Contract LHDA No.: **2219A**

Contract Name: **Installation of a hydraulically actuated Tresh Rack Cleaning Machine**

Subject: Change of material specification and Minimum requirement for the equipment needed. - Addendum No.2

4 ASSEMBLY

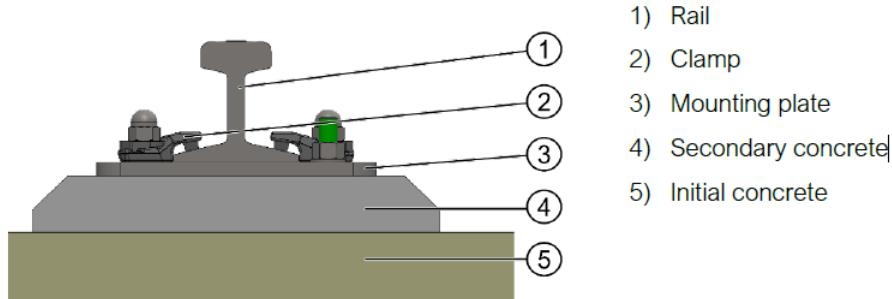
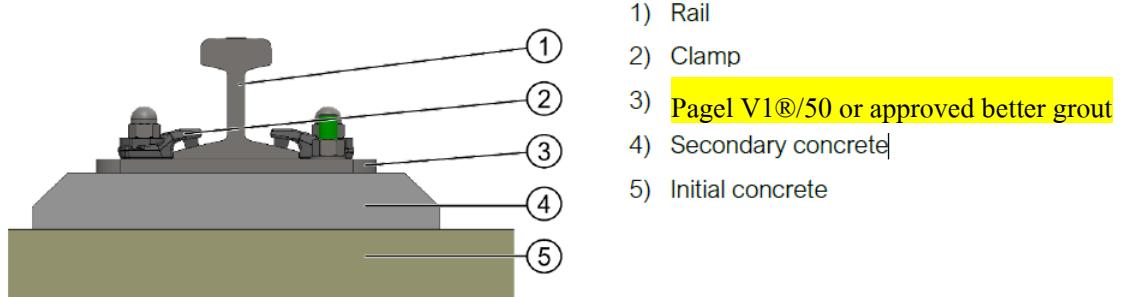
Replace “secondary concrete” (4) of Annexure 9, section 4, as shown below, with “Pagel or approved better grout”.

Instead of normal concrete, Pagel V1®/50 grouting shall be used to fill the space between the mounting plate and the initial concrete for the intake roof slab shown above. In cases where the Pagel V1® /50 grout is unavailable, the installation contractor may use the grout of similar or better properties than Pagel V1® /50. In that case, the bidder shall submit the supporting documents detailing the properties and performance of the proposed product for approval by the TRCM Contractor. The compressive strength of the proposed grouting materials shall be no less than 40N/mm² and 80N/mm² at 24 hours and 28 days, respectively. The bidder may also submit the product certification from the manufacturer. (See grouting details, Annexure 14)
